# **Comment Agenda**

## **162 cable assembly**

### **162A-D Annexes**

**Chris DiMinico**  
**MC Communications/PHY-SI LLC/Panduit**  
[cdiminico@ieee.org](mailto:cdiminico@ieee.org)

#71 haser\_3ck\_adhoc\_02\_061720.pdf

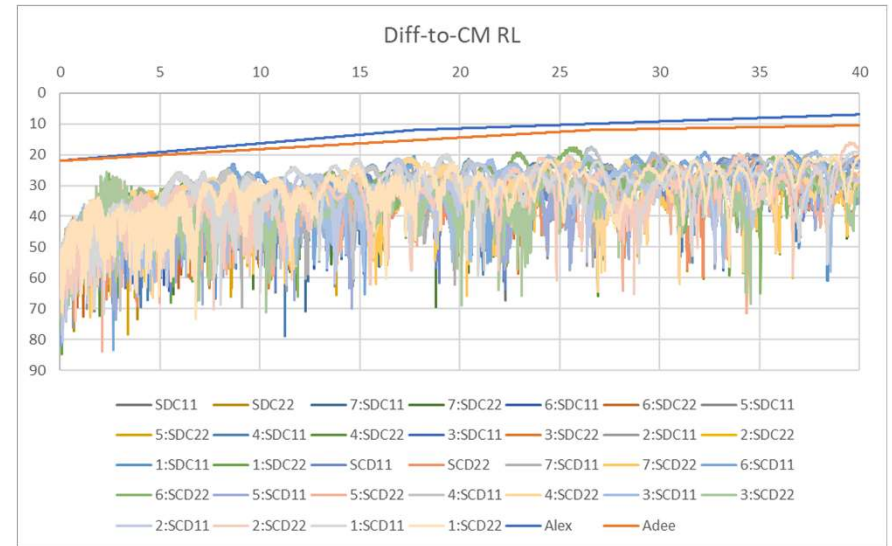
# CA DC RL – [71], 181, 148, 74,

## Differential to Common-Mode Return Loss:

$$\begin{cases} \left(22 - \frac{15}{26.56}f\right) \text{ dB} & 0.05 \text{ GHz} \leq f < 17.7 \text{ GHz} \\ \left(16 - \frac{6}{26.56}f\right) \text{ dB} & 17.7 \text{ GHz} \leq f \leq 40 \text{ GHz} \end{cases}$$

Alex # 71    Adee - #147

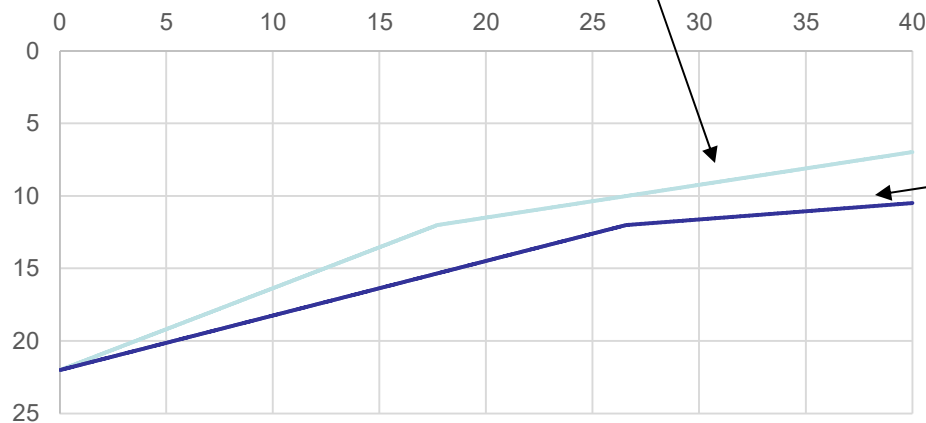
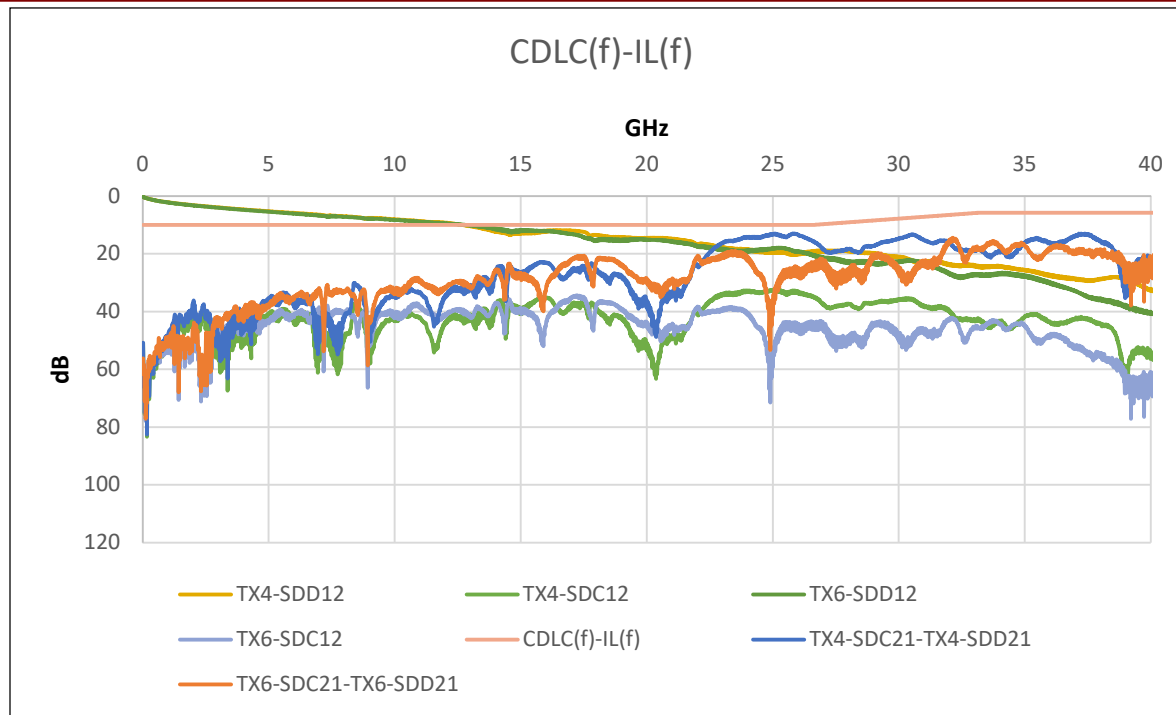
## common to differential mode RL proposals

#147 ---CDRL(f) ≥  
 $22 - 10 * f / f_N, 0.01 \leq f \leq f_N$   
 $15 - 3 * f / f_N, f_N < f < 40$   
 Where  
 $f_N = 26.5625$  is the Nyquist frequency in GHz  
 f is the frequency in GHz

# CA CC RL - [73],181,76

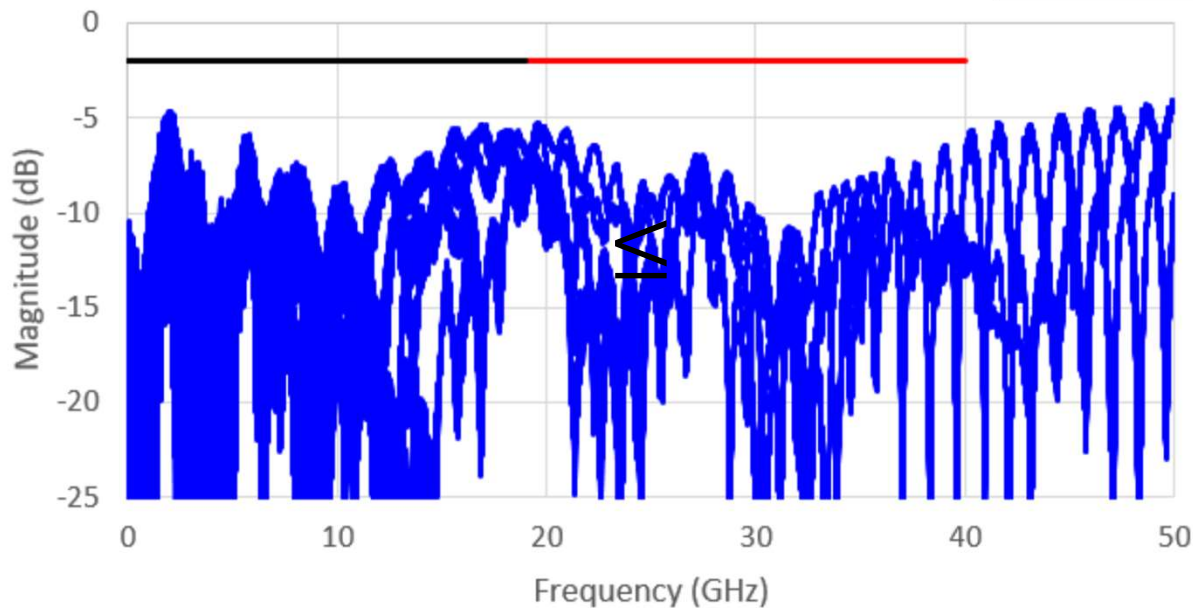
## Common-Mode to Common-Mode Return Loss:

**802.3ck proposal:** 2 dB  $0.05 \text{ GHz} \leq f < 40 \text{ GHz}$

Figure 92A-1—Insertion Loss Tx or Rx PCB max and min

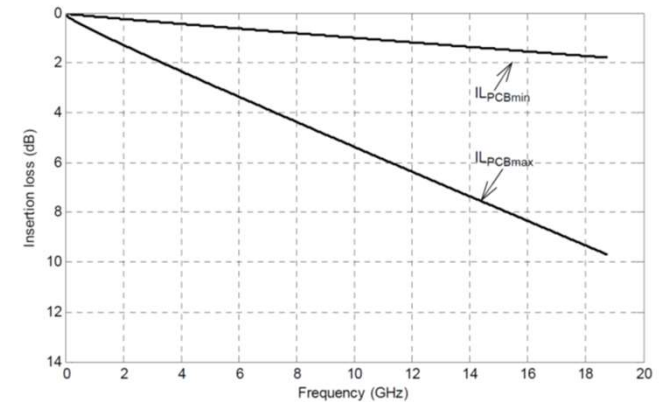
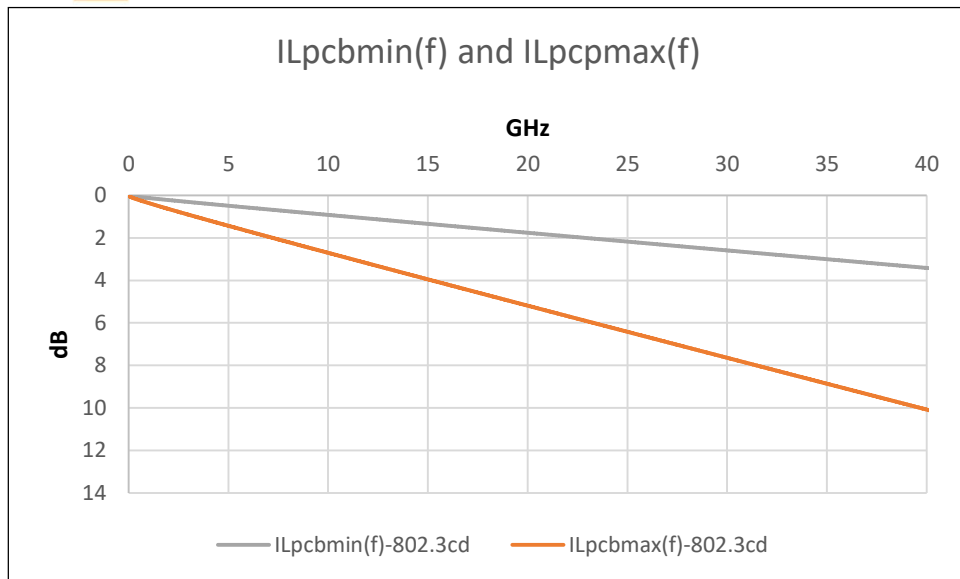
# Comment Agenda - #182

The recommended maximum and minimum printed circuit board trace insertion losses are specified in **TBD** and **TBD**, respectively.

Note that the recommended maximum insertion loss allocation for the transmitter or receiver differential controlled impedance printed circuit boards with allowances for ball grid array (BGA) footprint and host connector footprints is 6.875 dB at 26.56 GHz and the recommended minimum insertion loss allocation for the transmitter or receiver differential controlled impedance printed circuit boards is 2.3 dB at 26.56 GHz. The recommended maximum insertion loss allocation for the transmitter or receiver differential controlled impedance printed circuit boards is consistent with the insertion loss from TP0 to TP2 or TP3 to TP5 given in **TBD** and an assumed mated connector loss of 1.6 dB.

Editorial license update Annex reference to 162.11.2 ILCamin

# #86,87 - MTF Differential Return Loss

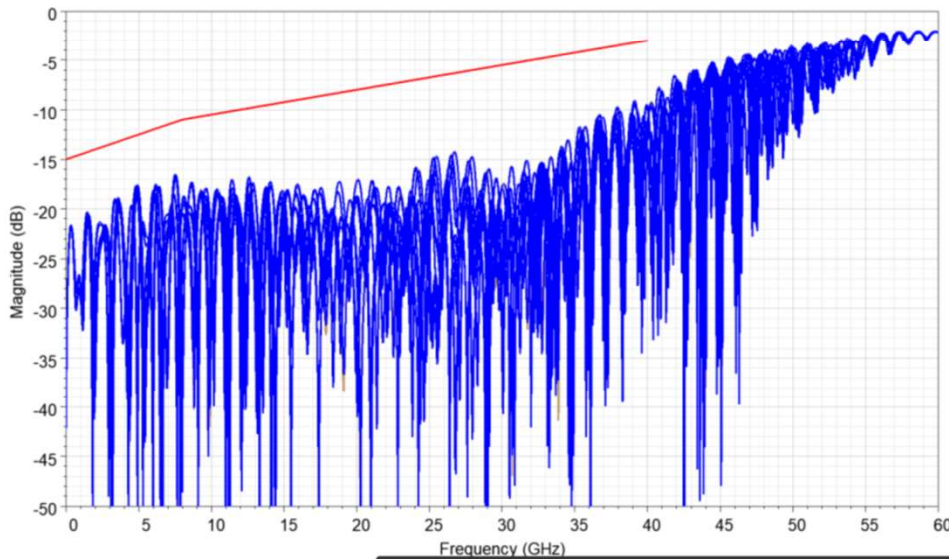
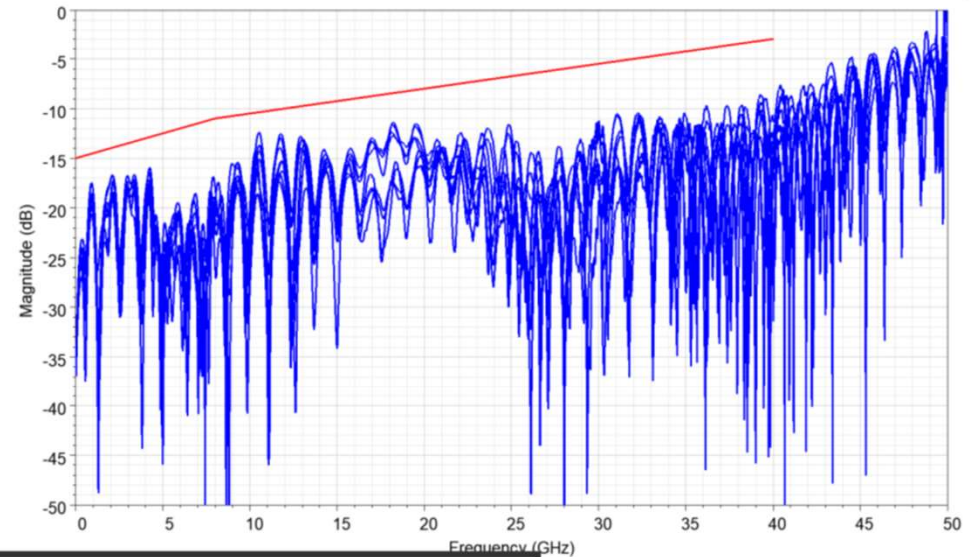
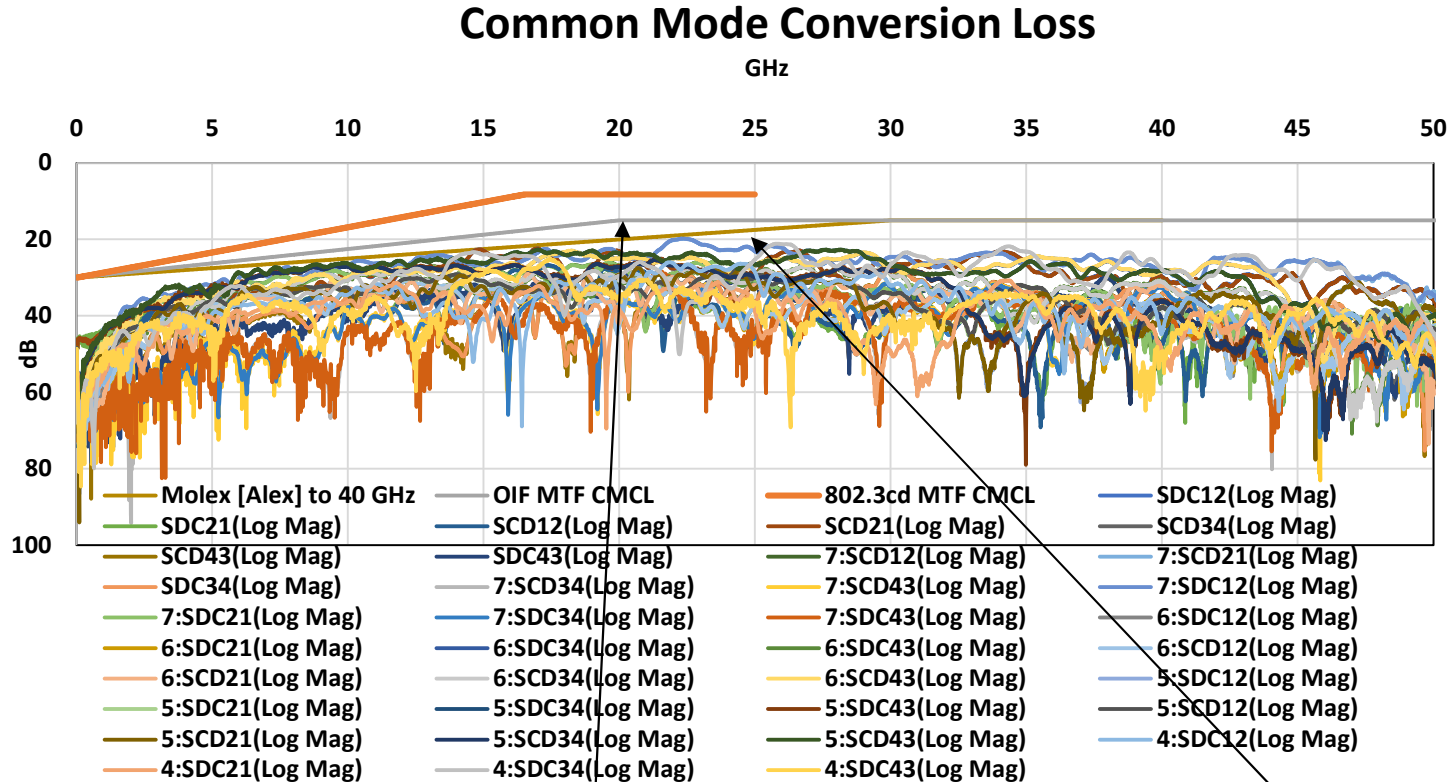
#86,#87 - 162B.1.3.2 Mated test fixtures - **RL (TBD)** - Change from 0.01 GHz  $\leq f_{\text{GHz}} \leq 50$  GHz to **0.05 GHz  $\leq f_{\text{GHz}} \leq 40$  GHz** and update figure.

NOTE: 802.3ck D1.2 does not include a limit line for this parameter

Proposal:  $15 - 0.5f$   $f < 8 \text{ GHz}$   
 $13 - 0.25f$   $8 \text{ GHz} \leq f \leq 40 \text{ GHz}$

# #88,#89 -162B.1.3.4 Mated test fixtures - CMCIL

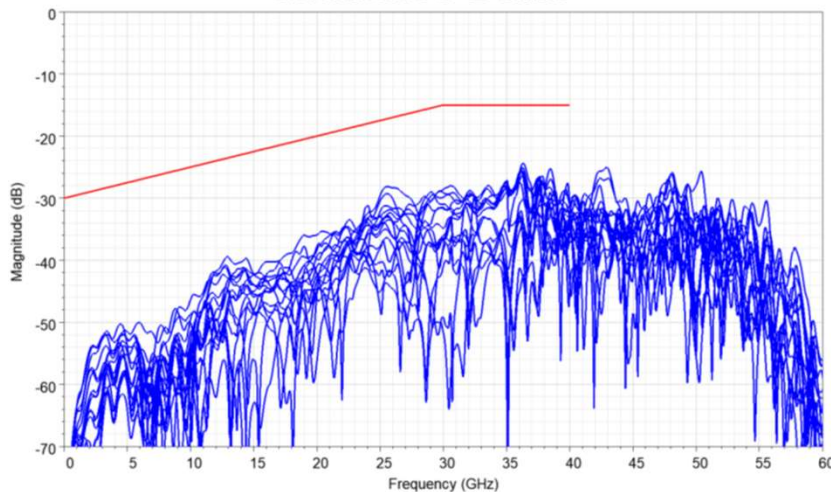
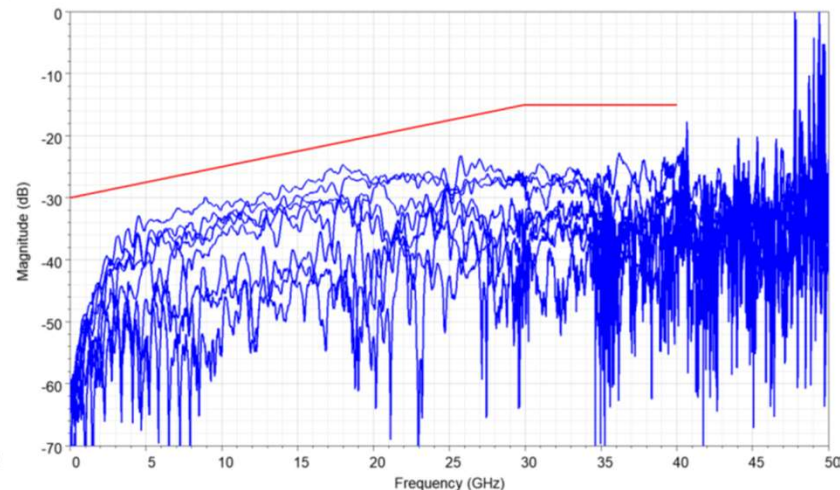
#88,#89 - 162B.1.3.4 Mated test fixtures - **CMCIL (TBD)** - Change from  $0.01 \text{ GHz} \leq f_{\text{GHz}} \leq 50 \text{ GHz}$  to  $0.05 \text{ GHz} \leq f_{\text{GHz}} \leq 40 \text{ GHz}$  and update figure.

NOTE: 802.3ck D1.2 does not include a limit line for this parameter

Proposal:	$30 - 0.5f$	$f < 30 \text{ GHz}$
	15	$30 \text{ GHz} \leq f \leq 40 \text{ GHz}$

# IL Frequency range Max – 79, 80, 81,82

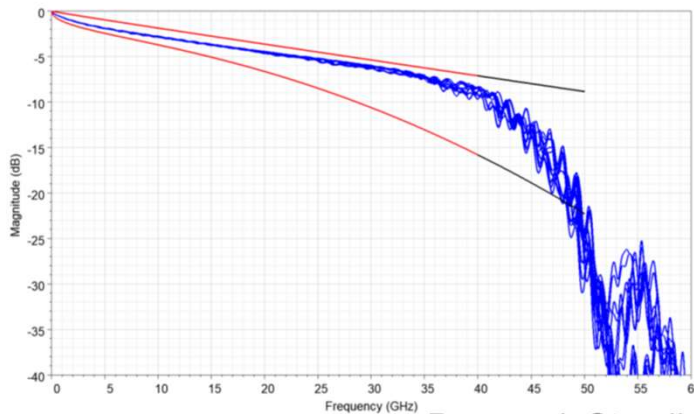
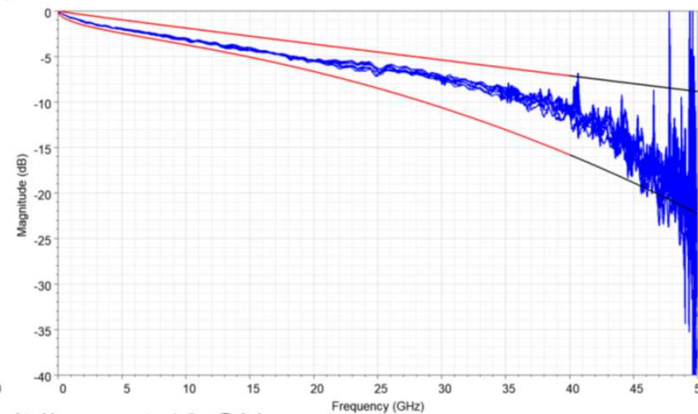
#79- 162B.1.1.1 Reference IL - Change from  $0.01 \text{ GHz} \leq f_{\text{GHz}} \leq 50 \text{ GHz}$  to  $0.05 \text{ GHz} \leq f_{\text{GHz}} \leq 40 \text{ GHz}$  and update figure.

#80- 162B.1.2.1 Cable assembly test fixture reference IL - Change from  $0.01 \text{ GHz} \leq f_{\text{GHz}} \leq 50 \text{ GHz}$  to  $0.05 \text{ GHz} \leq f_{\text{GHz}} \leq 40 \text{ GHz}$  and update figure.

#81,#82- 162B.1.3.1 Mated test fixtures max and min IL - Change from  $0.01 \text{ GHz} \leq f_{\text{GHz}} \leq 50 \text{ GHz}$  to  $0.05 \text{ GHz} \leq f_{\text{GHz}} \leq 40 \text{ GHz}$  and update figure.

Proposal: Stop limit lines at 40 GHz

# In support of IL Frequency range Max – 79, 80, 81,82

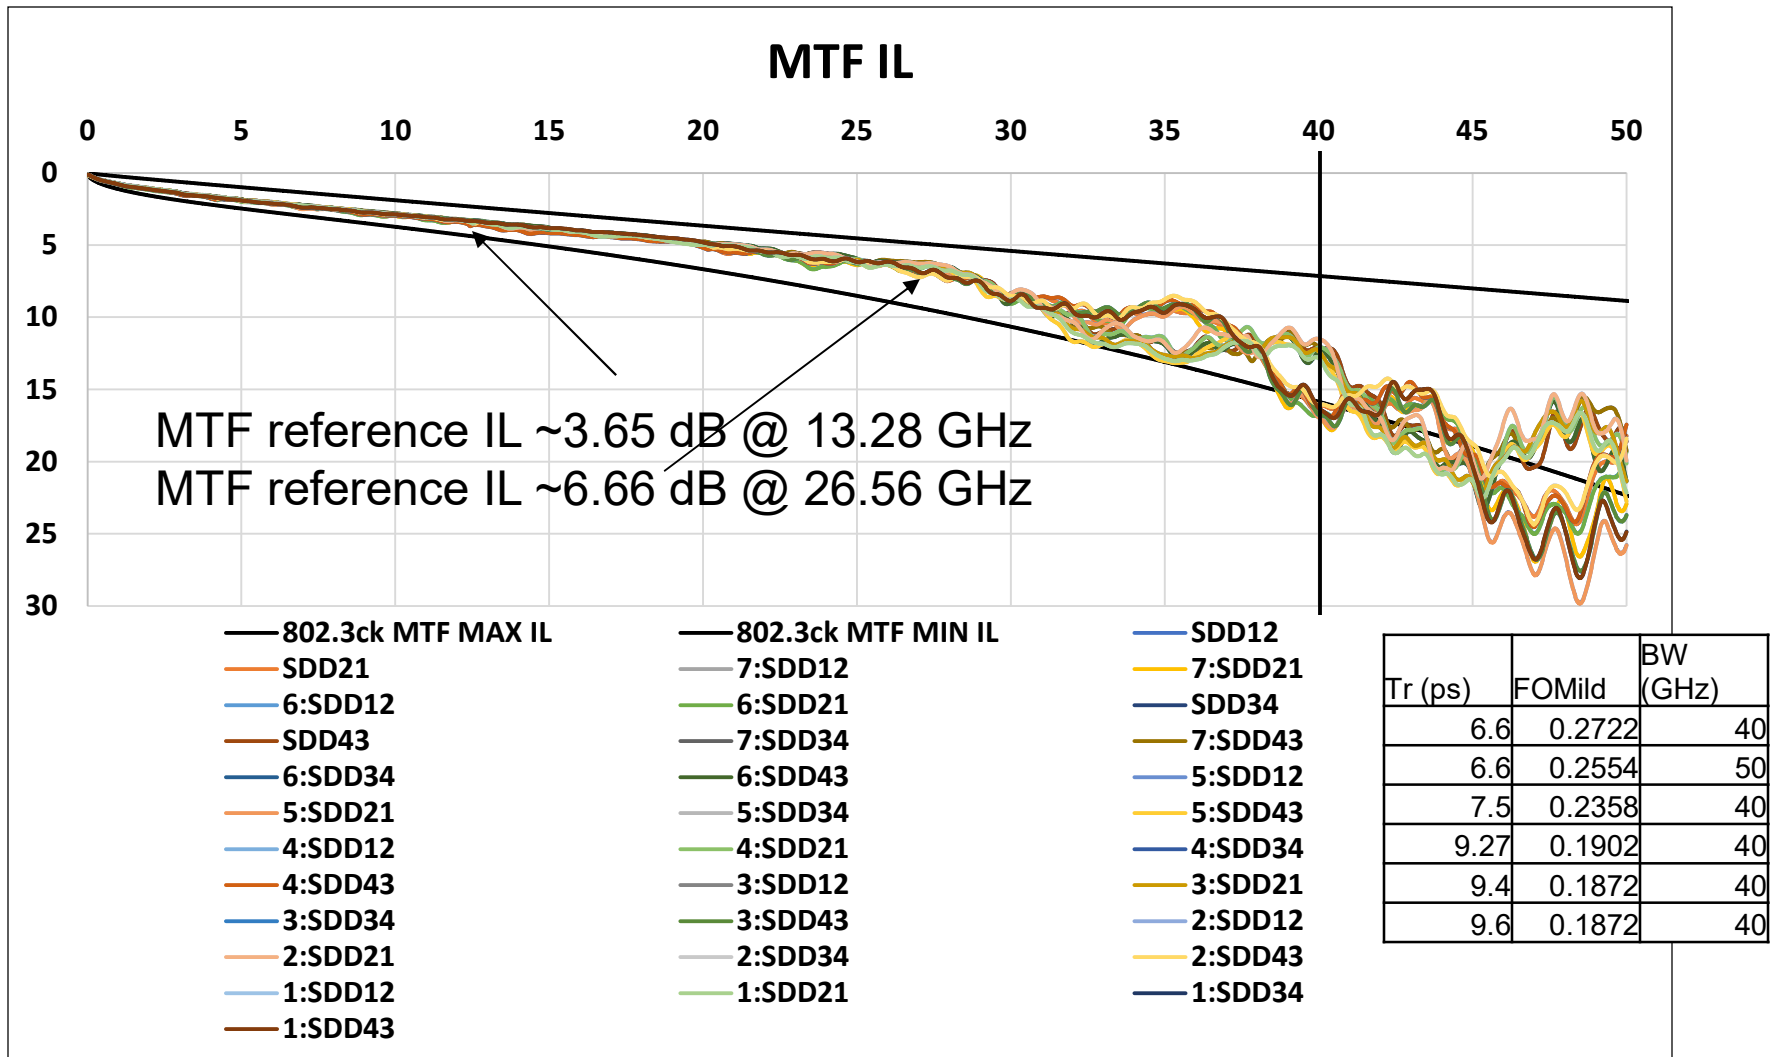
- Measurements with compliant PCB IL - HCB and MCB
